DATE: 02.27.2019
TO: ProTrak
FROM: Mitesh Baxi
Traffic Engineering

■ **BIRCHWOOD DRIVE ACCESS PLAN [TRC Plan Review]**

↻ Initial Review Note ↻

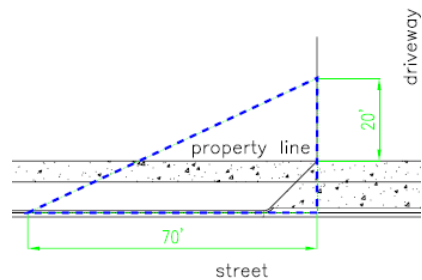
- Revise relevant sheets to accurately illustrate the existing conditions on and surrounding this parcel. Show all adjacent traffic signs, lane configurations, traffic control devices and pavement markings for the Birchwood Dr/Market St on the site plan. Please refer to the Technical Standards and Specifications Manual (link is below) Ch. VII C.1.a.2. for specific information and distance requirements. Contact Traffic Engineering at 341-7888 if you need assistance locating these elements.
<https://www.wilmingtonnc.gov/home/showdocument?id=1910>
- Please show the existing ramps, warning domes or any missing details for the intersection of the proposed driveway with Birchwood Dr.
